EM MICROELECTRONIC-MARIN SA

Process Change Notification

PCN: 19-005

Part numbers affected: EM4237V1WS6E
EM4237SLICV1WS6E
EM4237SLIXV1WS6E

IC CONNECTION SCHEME

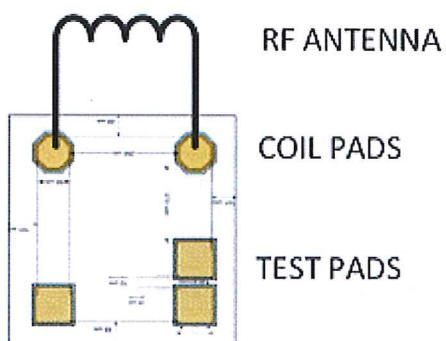
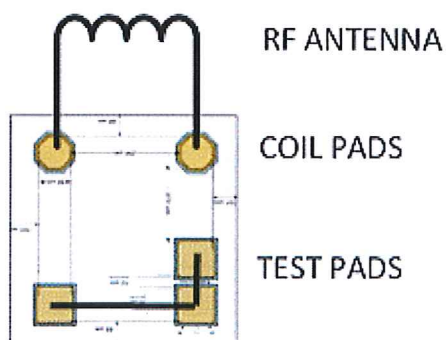
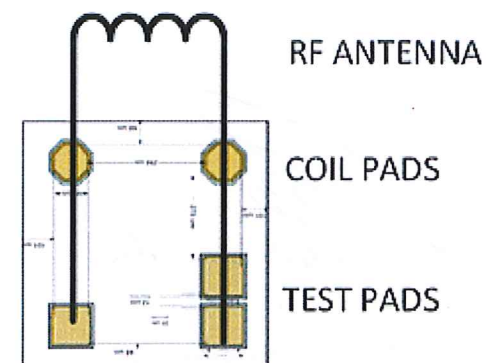
IC layout changes of metal interconnect layers around 3 test pads.

Reduction of parasitic coupling between the residual test pad connection and circuitry adjacent to pad.

No change to the 2 coil pads connected to antenna.

ESD risk
during IC
assembly

ESD risk
during IC
assembly

OK

OK
